CHAMPION AIRCRAFT CORPORATION  
Osceola, Wisconsin

SERVICE LETTER #20

SUBJECT: Installation - Instructions - "No-Bounce" landing gear oleo assembly.

AIRPLANES AFFECTED: Optional modification of any Model 7AC, 7BCM, 7CCM, 7DC or 11 series airplane.

FIGURE NO.1 FOR USE WITH SERVICE LETTER NO. 20.

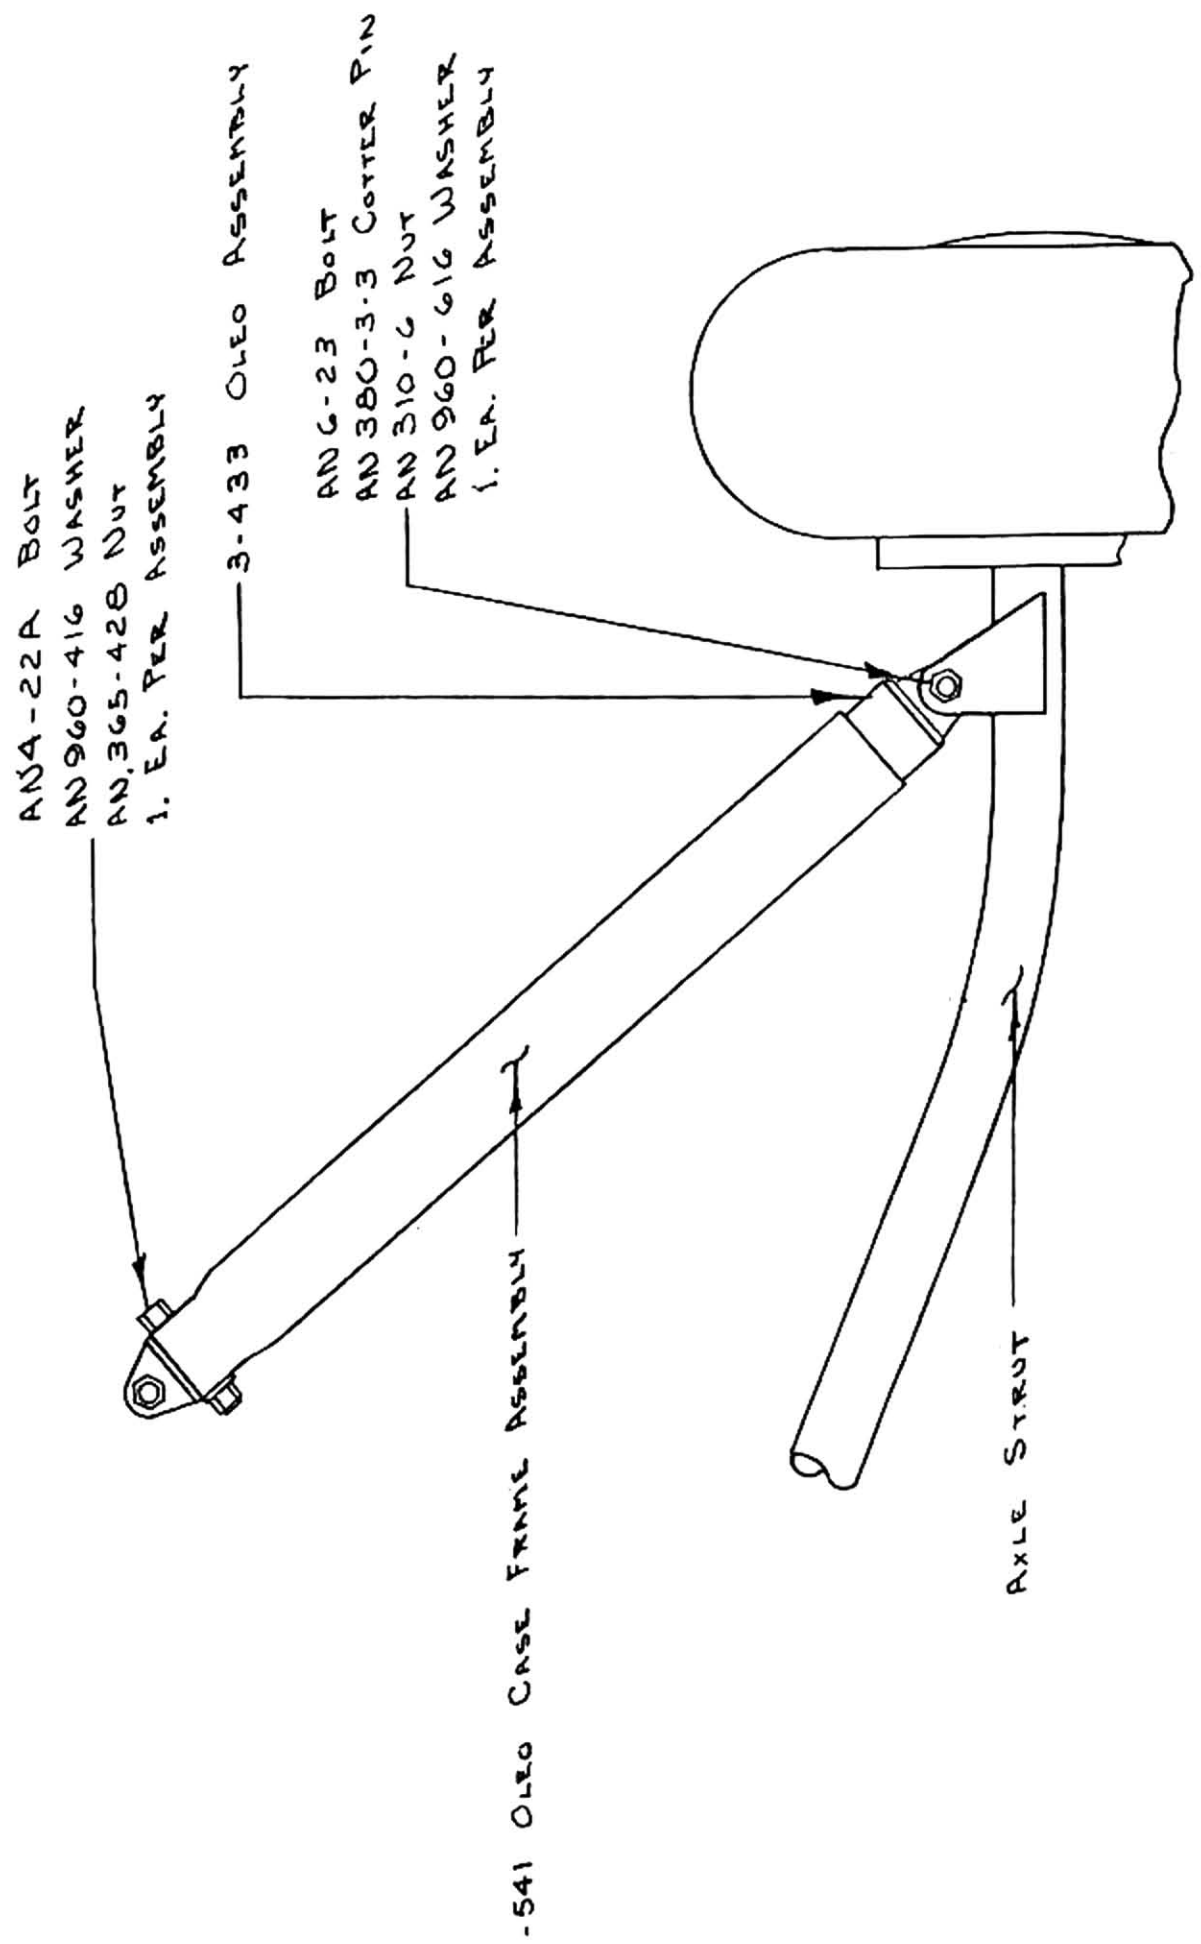
1. Jack up the airplane so that all weight is removed from the landing gear.
2. Remove the AN365-482 nut, AN960-416 washer and AN4-22A bolt, located in the upper end of the 2-700 (2") forward Strut, or the 4-541 oleo case frame assembly. (See Figure 1).

3. Remove the AN380-3-3 cotter pin, AN310-6 nut, AN960-616 washer and AN6-23 bolt, attaching the lower end of the 3-433 oleo assembly, to the axle strut. (See Figure 1).

FIGURE No: 2 FOR USE WITH SERVICE LETTER No. 20

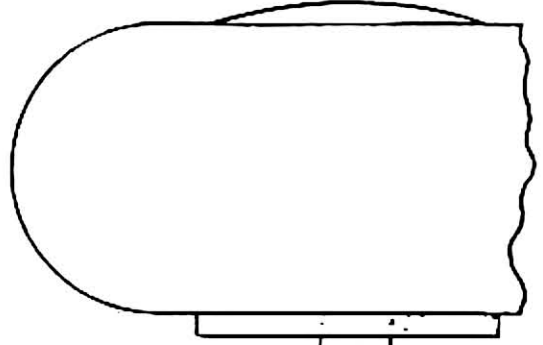
4. Remove the 3-433 oleo assembly from the 4-541 oleo case frame assembly.
5. Line ream the  $\frac{1}{8}$  inch diameter hole, in the upper end of the 2-700 (2") forward strut, of the 4-541 oleo case frame assembly to  $3125^{+.001}$  Diameter. (See Figure 2).

.3125<sup>+.001</sup> LINE REMN TARN.  
C.L. OF HOLE MUST PASS WITHIN  
.002 OF TUBE C.L. AND BE SQ.  
WITH C.L. OF TUBE WITHIN .002

FIGURE No. 3 FOR USE WITH SERVICE LETTER No. 20

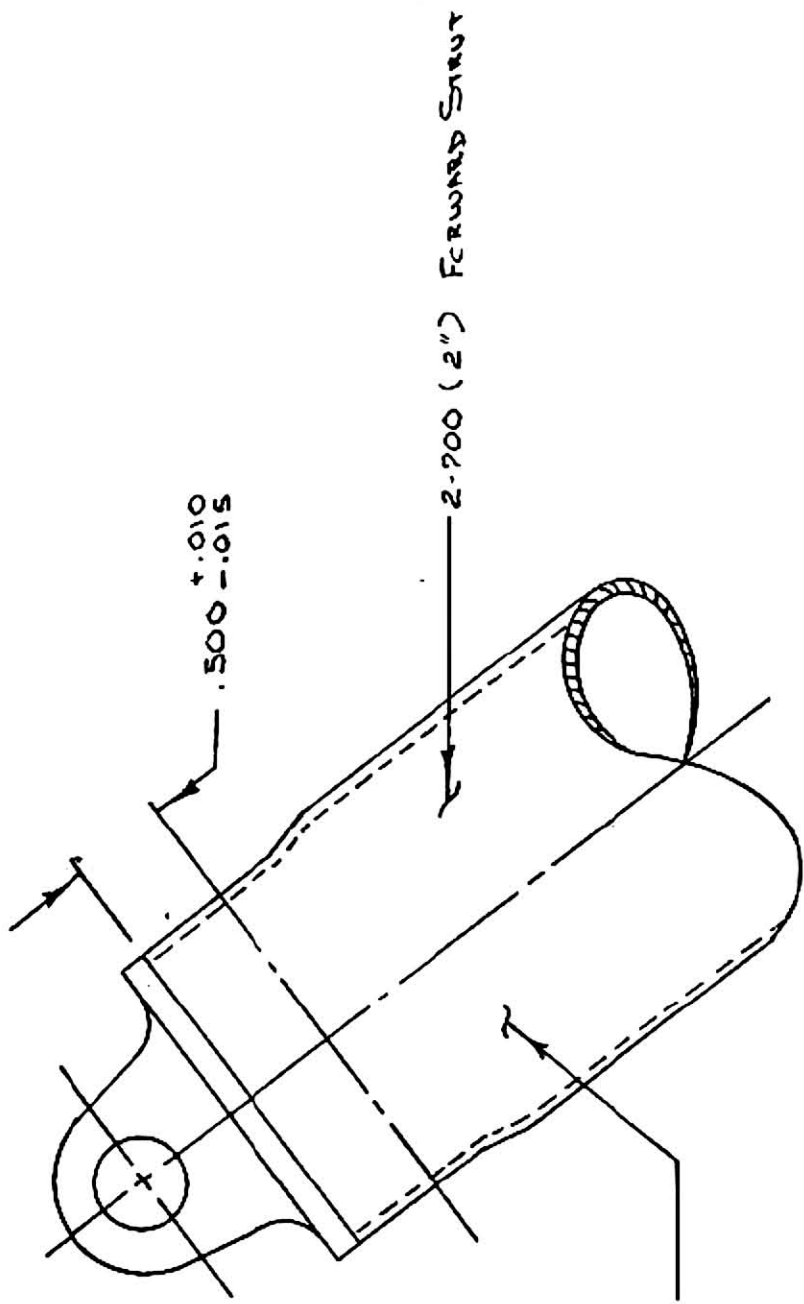
6. Install the 3-665 "No-Bounce" oleo assembly, in the 4-541 oleo case frame assembly. (See Figure 3)
7. Align the bushing located in the upper end of the 3-665 "No-Bounce" oleo assembly with the reamed hole in the 2-700 (2") forward strut, of the 4-541 oleo case frame assembly, and insert a AN5-22A bolt. Install a AN960-516 washer and AN365-524 nut on the AN5-22A bolt and tighten.

8. Attach the 3-665 "No-Bounce" oleo assembly, to the fitting at the lower end of the axle strut, using the original AN6-23 bolt, AN960-616 washer, AN310-6 nut and AN380-3-3 cotter pin. Should the original bolt show signs of wear, however, it should be replaced.
